INSTRUCTION TO SERVICE

ITS: 5733	
SECTION:	219 Engine and Transmission
WRITTEN BY:	Mike Pearson
SUBJECT:	Replacement Engine Belt Guard and Trans Dipstick Bracket

Figure 1: Replace Existing Engine/Alternator Belt Guard

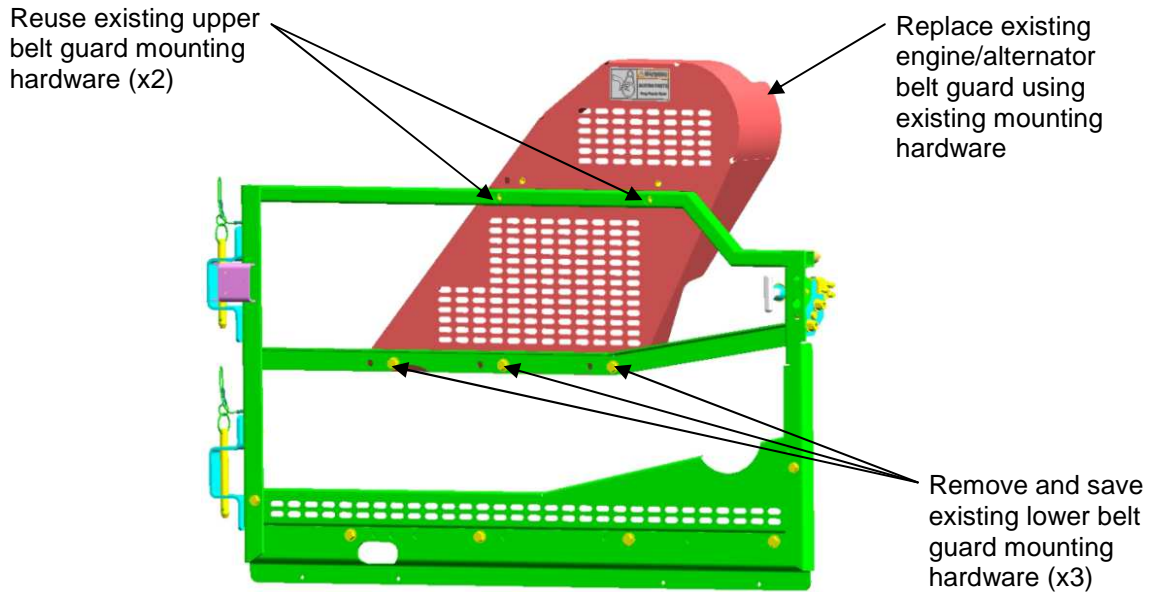
1. Turn the main battery disconnect switch to the "OFF" position.
2. Open the rear engine access door.
3. Undo the belt guard rubber latch and swing the belt guard assembly open.
4. Remove and replace existing alternator belt guard p/n 340386 with new belt guard p/n 433537 using existing mounting hardware (x5). See Figure 1.

Figure 2: Install New Engine/Alternator Belt Guard Warning Decal

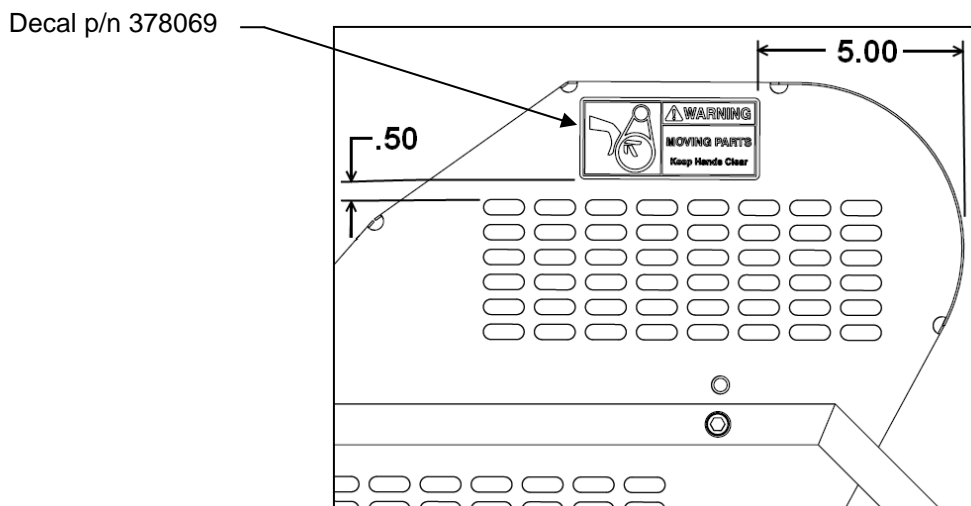
5. Install new warning decal p/n 378069 at dimensions shown in Figure 2.

Figure 3: Remove Old Transmission Dipstick Mounting Bracket

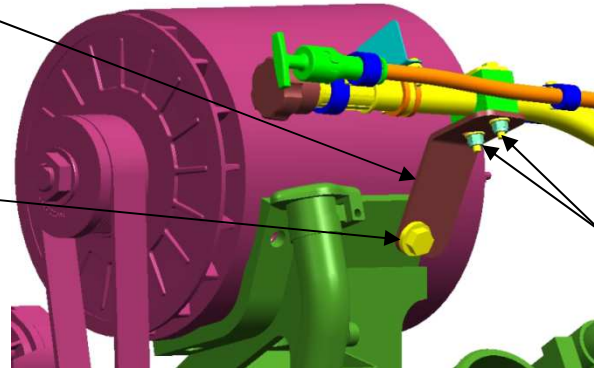
6. Remove and save existing transmission dipstick clamp mounting hardware for reuse (x2), see Figure 3.
7. Remove and save existing transmission dipstick mounting bracket bolt and washer for reuse, see Figure 3.

Replace existing transmission dipstick mounting bracket with new bracket p/n 328729 (**Rev B**)

Remove and save existing transmission dipstick mounting bracket bolt and washer for reuse

Remove and save existing transmission dipstick clamp mounting hardware (x2),

Figure 4: Installing New Transmission Dipstick Mounting Bracket

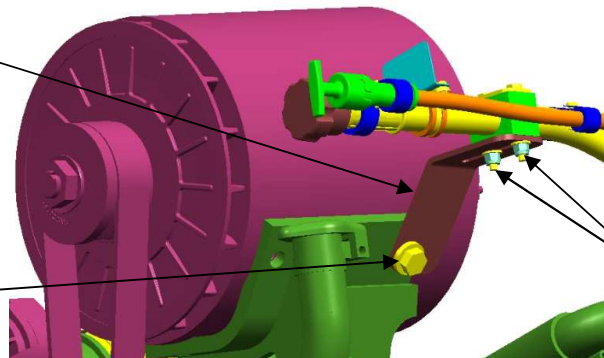
8. Replace existing trans dipstick mounting bracket with new bracket p/n 328729 (**Rev B**), secure to existing alternator bracket using existing bolt and washer removed in Step 7, discard old bracket. Torque existing $\frac{1}{2}$ " bolt to 55-65 ft*lbs, see Figure 4.
9. Secure the existing trans dipstick clamp and dipstick assemblies to the new bracket using the existing hardware removed in Step 6, install so maximum distance between the alternator and the transmission dipstick is achieved, see Figure 4.

Install new transmission dipstick mounting bracket p/n 328729 (**Rev B**)

Install new bracket using existing hardware from step 6, torque existing $\frac{1}{2}$ " Bolt to 55-65 ft*lbs

Secure to Bracket using existing hardware removed in Step 6
